Subject: Preventive measure against unintentional PIO (pilot induced oscillations).

Serial number applicability: All ASW 20 and 20 L, serial no.s 20001 thru 20611.

Compliance: Accomplishment of the action required under this T.N. until the next annual glider inspection, but at the latest until March 31, 1988.

Datum	Name	Typ	Benennung	Maßst.
				Bearb. 16.10.1878	Herrmann	ASW 20	Ausgleichsstück für Steuerknüppel	1:1
				Geprü.				
				Norm				
				A. Schleicher Segelflugzeugbau 6416 Poppenhausen		Zeichnungsnummer L-314 200.48.0012		Blatt
								Bl.
Zust.	Änderung	Datum	Na.	Urspr.	Ers. f.	Ers. d.

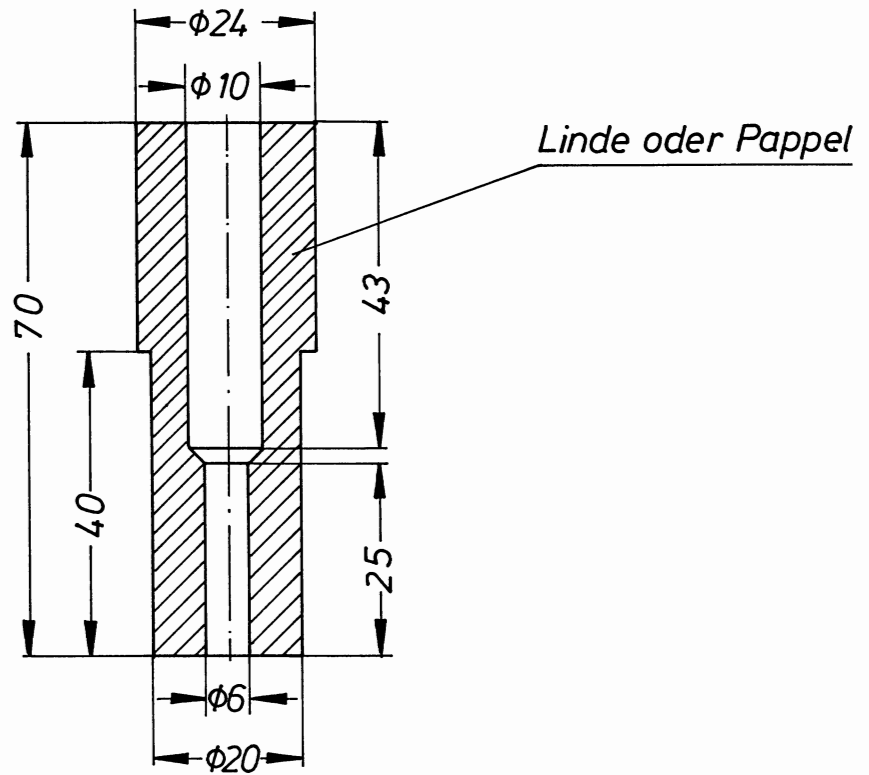
1. Check that your stick form is identical with the enclosed drawing (200.48.001). Only sticks with this stated crank angle are permissible; sticks differing from that are no longer allowed, even if there should be a previous LBA-approved Modification For A Single Unit for another stick type. Re-install the original stick type. In the case that a brake lever is (to be) fitted to the stick, the extension by means of the wooden compensating piece (200.48.0012) is permissible.

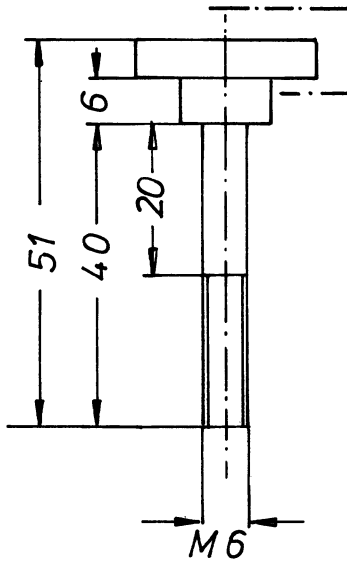
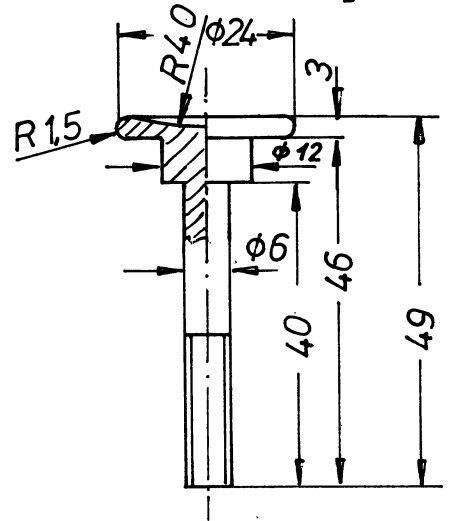
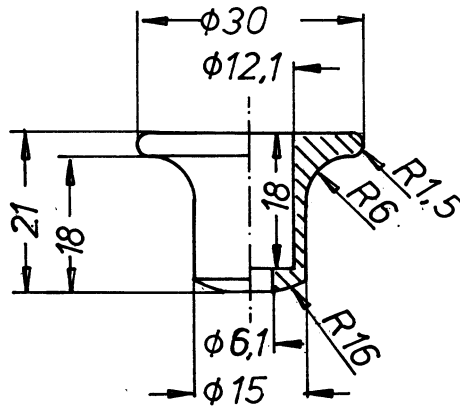
3. Remove the existing trim knob; as the landing gear locking mechanism is no more secure while works at the trim are accomplished, the seatpan has to be removed also and the fuselage must be jacked up. The new, spring-loaded trim knob must be installed as shown on drawing 200.49.0030. Attention must be paid that the green knurled head screw ① is absolutely locked with the retaining nut ⑦.

With the elevator in the zero position, the trim knob must be adjusted at about 10 mm behind the front edge of the slotted gate; the adjustment is done at the universal joint of the trim spring pot. Finally check that all parts are free-moving and re-install the seatpan.

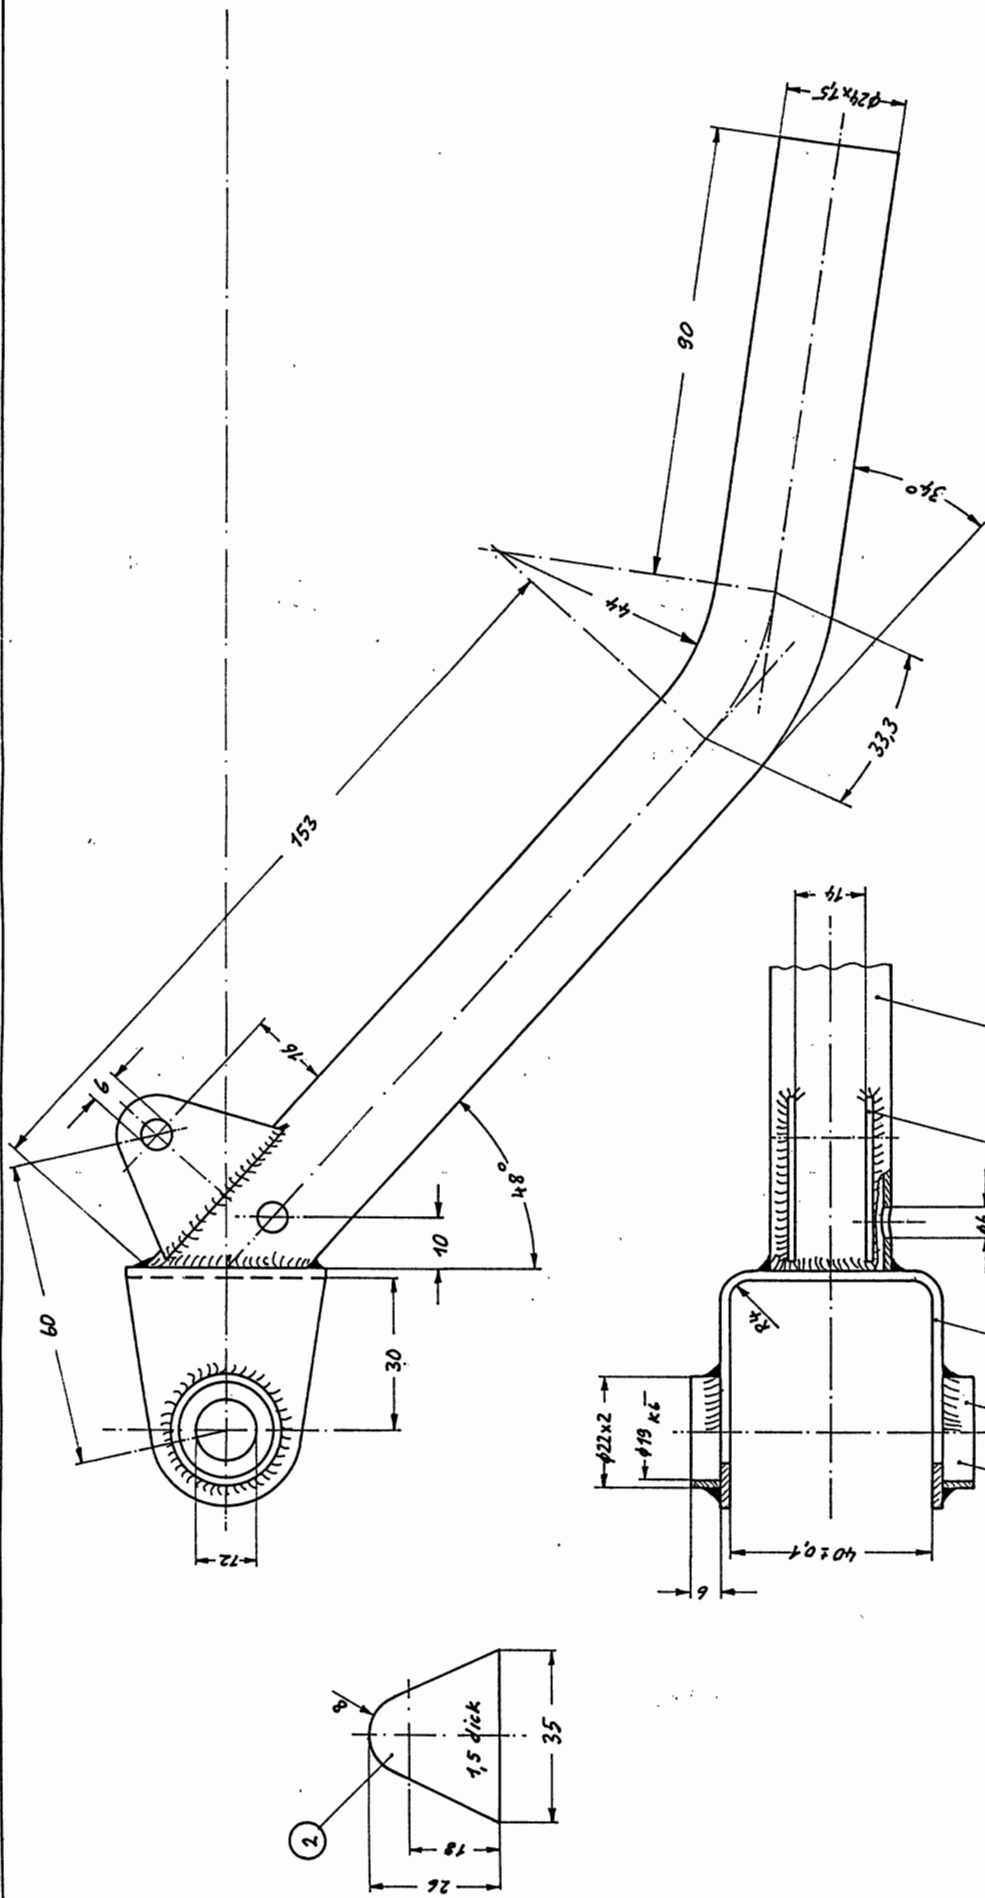
Sticks which are either too much cranked or misplaced too far to the rear, favor PIOs because in rough air the forearm and the hand on the stick are propped up behind the universal joint of the stick and from this unintentional elevator deflections result which still reinforce the maneuvering g-loads.

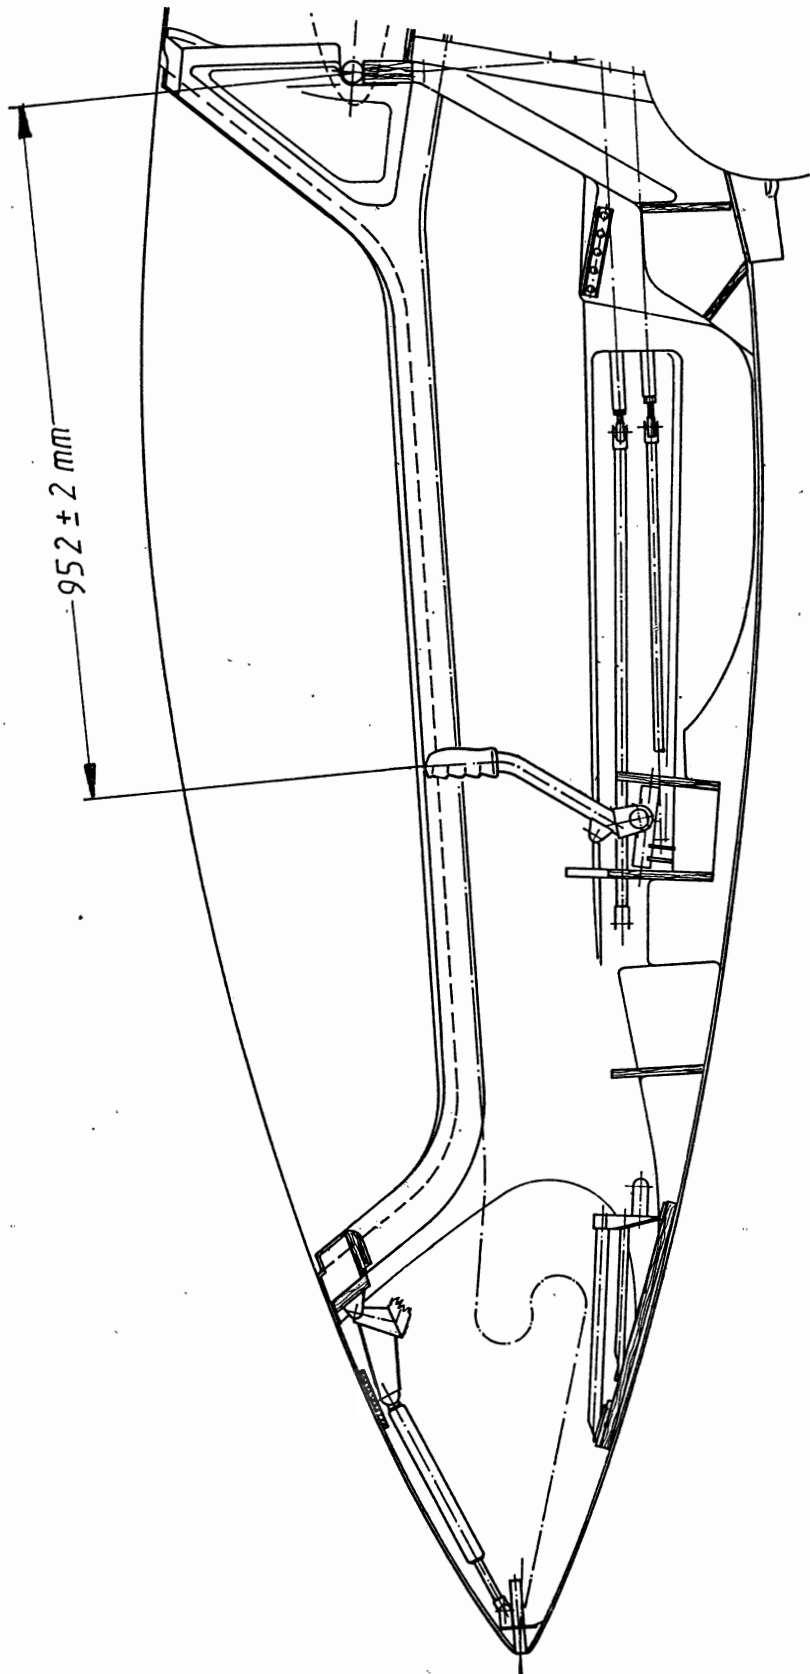
2. Check the most forward position of the stick as per drawing (200.11.S4) and if necessary re-adjust. The adjustment is done at the variable head in front of the stick; for this purpose the elevator must also be in the full down position within the tolerances given in the Operations Manual page 42 (ASW 20) or page 46 (ASW20 L).
